Appin Mine - Longwalls 709 to 711 and 905 Extraction Plan

ATTACHMENT A – Response to IAPUM Advice and SA NSW Submission

ATTACHMENT B – Appin Longwall 709-711 and 905: Groundwater and surface water effects

Figure 1. Comparison of BSO "base plan" and the proposed Extraction Plan layout

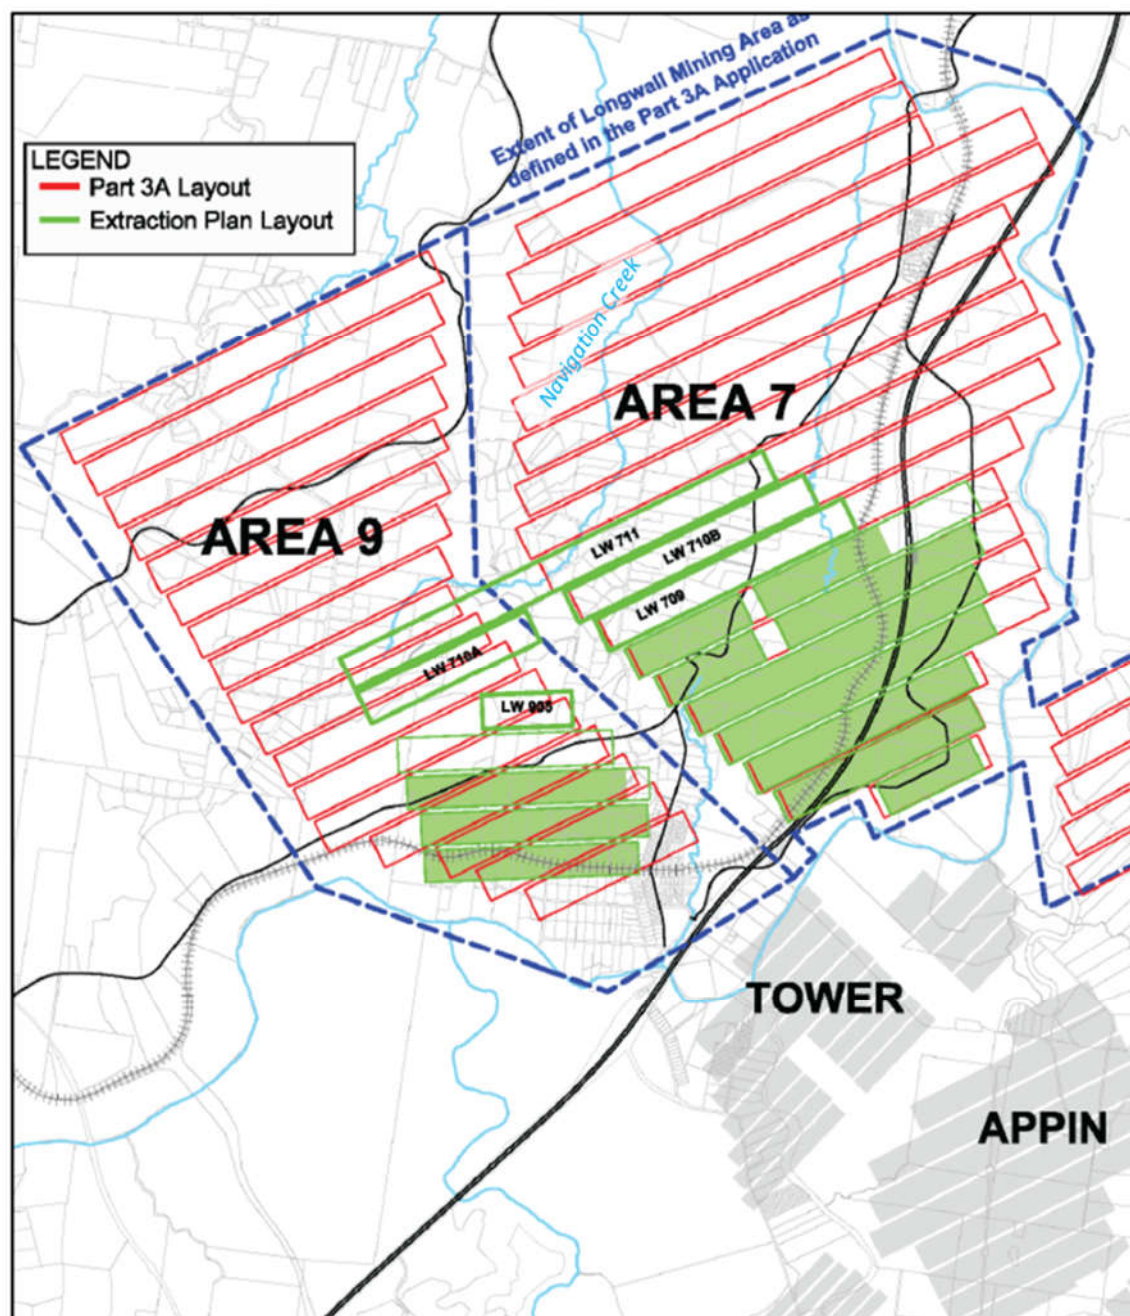
Illawarra Metallurgical Coal (IMC) is currently seeking Subsidence Management Plan (SMP) approval for Longwall 709 to 711 and 905 at the Appin Mine. In the Bulli Seam Operations (BSO) Approval (base plan), Areas 7 and 9 were separate mining domains with non-subsiding headings dividing the areas. IMC proposes a new mine plan which includes longer single longwalls spanning the two areas, with Longwall 711 the first in this series (Figure 1). In assessing the new mine plan, the Department of Planning and Environment (DPE) has requested clarification in relation to potential impacts to surface water. Specifically, DPE requested:

- *discussions of surface and groundwater impacts and environmental consequences of the full range of subsidence predicted by MSEC likely to be experienced by third order sections of Navigation Creek traversing LW711*
- *comparison of these impacts against the impacts assessed in the original EA and the PPR*
- *confirmation that the assessed impacts would not exceed the performance measures for watercourses included in the BSO consent (Condition 1 of Schedule 3).*

Navigation Creek is a third order stream that traverses above Longwall 711. The catchment area of Navigation Creek to its confluence with the Nepean River is approximately 24.9 km². Approximately 1.2 km length of Navigation creek overlies proposed Longwall 711. In the original BSO base plan, approximately 830 m of that length overlay the non-subsiding headings between longwalls of Areas 7 and 9. Therefore, under the revised mine plan, that length of Navigation Creek will be subject to additional ground subsidence and associated effects compared with the original BSO base plan in the EA (Figure 1). The area is highlighted as a red rectangle ["Area of Interest"] on the attached map reproduced from MSEC (2009) (Drawing 404-201), and the attached map (Drawing APNSVY00112A) of the proposed mine layout.

- The proposed mine plan will result in overall lower total subsidence in Areas 7 and 9, including above Navigation Creek.
- The ~850 m reach of Navigation Creek that traversed the non-subsiding headings in the original BSO Mine Plan will experience subsidence effects in the proposed layout that are similar to other third-order watercourses that overlie longwalls.
